Council Reference: A007017328
Attention: Alexandria Wood

RE: Response to Information Request – Development Permit for Material Change of Use (Six Townhouses) at 44 Kates Street, Morningside

Figure 1: Proposed Site Plan with Increased Setback to Front Walls – Zarchitects (8 June 2026)

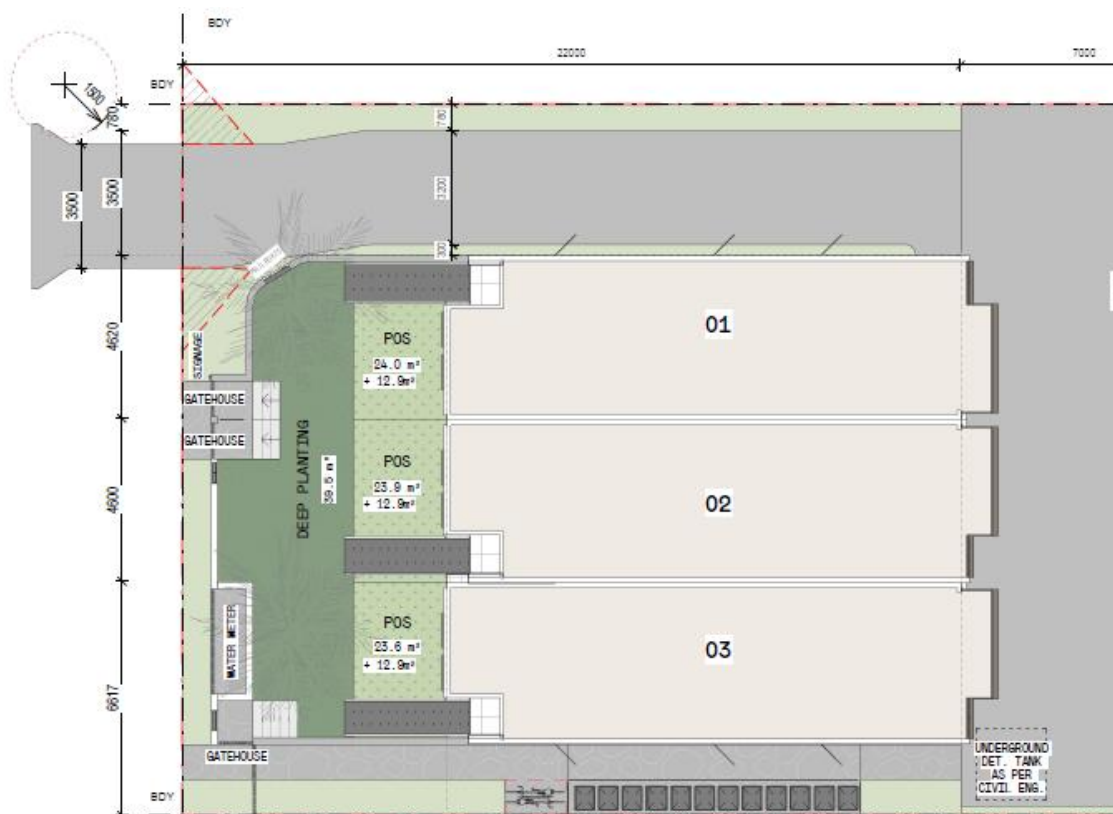
1. The proposed plans note that gatehouses, water meters and walls dominate the frontage which limits space for shade tree planting and detracts from the streetscape amenity. A minimum 2m wide landscape strip should be provided along at least 50% of the frontage with refuse bin enclosures and walls located behind this landscaping in accordance with PO28/AO28.1 of the Multiple dwelling code.

- a. Provide amended plans that show a minimum 2m wide landscape strip along at least 50% of the frontage with bin enclosures and walls located behind this landscaping.

Note: The refuse bin storage areas for Townhouses 1, 2 and 3 must be accessible internally without the need to enter the road reserve and cannot be accessed through deep planting areas, dwellings or garages. The access doors to the refuse bin storage areas for Townhouses 1, 2 and 3 must not open onto the road reserve. An internal access pathway to the refuse bin storage areas will need to be provided on the revised plans.

2. The eastern side of the subject site does not provide sufficient landscaping in accordance with PO28/AO28.2 of the Multiple dwelling code. The landscaped area along the eastern side boundary should be redesigned to accommodate screening vegetation, contributing to building separation and privacy. The pedestrian pathway should be aligned adjacent to the building line. Waste bins may be located at the boundary, within a designated gap in the landscaped strip.
 - a. Provide amended plans demonstrating a minimum 1.5m wide landscaped strip along the eastern side boundary. The pedestrian pathway is to be relocated along the building line, incorporating a gap for bin storage.

As detailed on both the accompanying proposal plans and landscape plan, the previously proposed bin stores have been removed from the front of the site. The proposed gatehouse and front walls have been retained with a setback 1000mm from the road boundary. The removal of the bin stores has allowed for the 1000mm setback to be clear of built form across the entire width of the frontage. As detailed on the proposed landscape plan this front setback is to be landscaped with shrubs and ground covers to assist with visual amenity within the streetscape. The removal of the bin stores has allowed for additional deep planting within the front setback between the structures and the road boundary assisting in softening the development from the street.

As indicated within Figure 1 above, the pedestrian access path has been realigned to directly abut the eastern elevation of Townhouse #3. All bins including those previously proposed at the front of the site have been relocated to the bin store, which is now proposed in a screened enclosure along the eastern boundary, as advised by Council. Where possible columnar trees and screen planting have been provided in the 1000mm wide landscape strip along the boundary. As outlined within the Planting Schedule within

Figure 3: Proposed Bulk Earthworks Plan – Motus Consulting (18 June 2026)

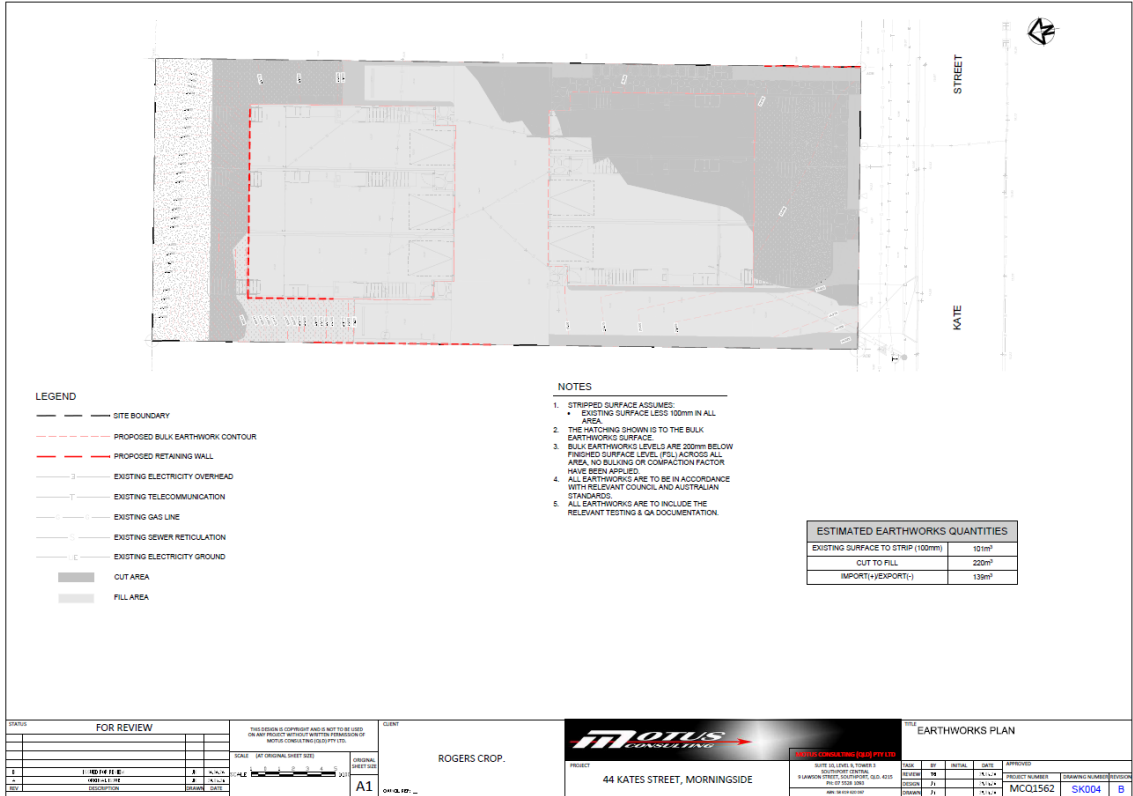
3. An Earthworks Plan is included in the 'Engineering Services Report'; however, the plan does not include sufficient details on the extent of cut and fill and proposed retaining wall heights. In accordance with PO1 and PO2 of the Filling and excavation code, the following information is required:

- a. Provide a preliminary concept earthworks plan that shows the proposed retaining wall heights on elevation plans.

b. Provide a preliminary concept earthworks plan that includes cross sections showing the proposed extent of cut and fill.

Note: The maximum height of a retaining wall on a property boundary retaining fill and presenting outwards is to be one metre. Any further retaining is to be stepped with a minimum one metre horizontal step between the tiers.

Accompanying this submission are plans prepared by Motus Consulting which detail the extent of cut and fill proposed and cross sections detailing the proposed works. All proposed works are consistent with the Filling and Excavation Code. As illustrated, there will be no large fill retaining walls presenting to the street or adjoining properties.
